ADDENDUM NO. 3

**TO THE
CONTRACT DOCUMENTS FOR
GILLETTE TENNIS / PICKLEBALL FACILITY
CITY OF WILSON, NORTH CAROLINA**

From: **Green Engineering, P.L.L.C.
Consulting Engineers
Wilson, North Carolina**

Gillette Pickleball and Tennis Complex
Request for Information No. 1
March 28, 2023

2
B-3

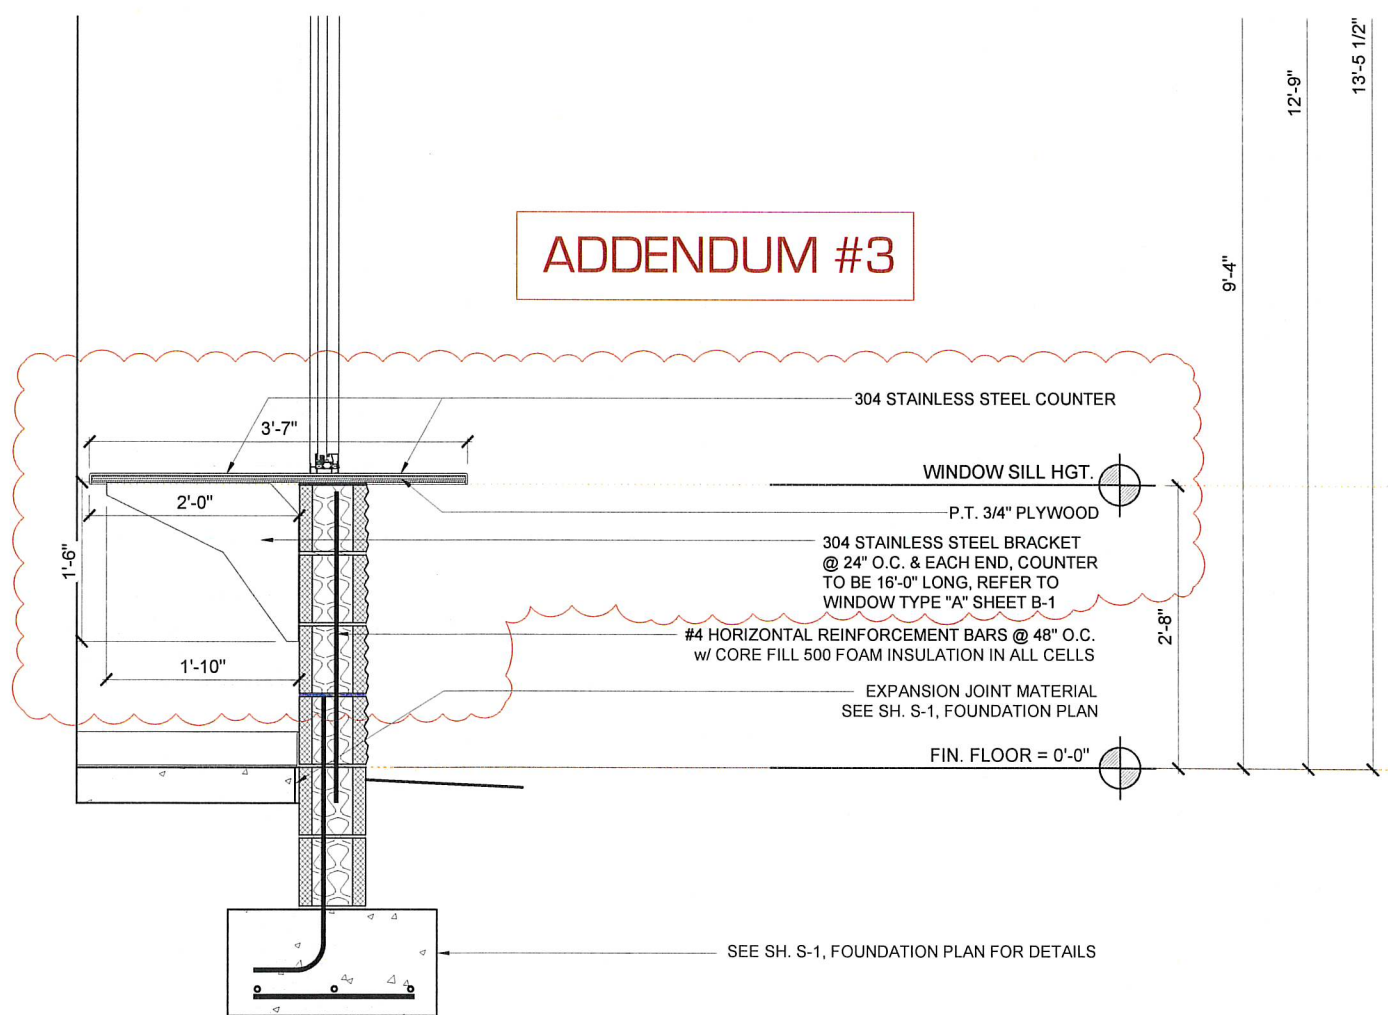
17. Concession Building – Sheet B-3 indicates stainless steel counter to be provided. Please provide design and specification for stainless steel counter.

Stainless Steel counter to be 22 Ga. 304 Stainless Steel over 3/4” PT plywood, see attached drawing dated 4-5-23.
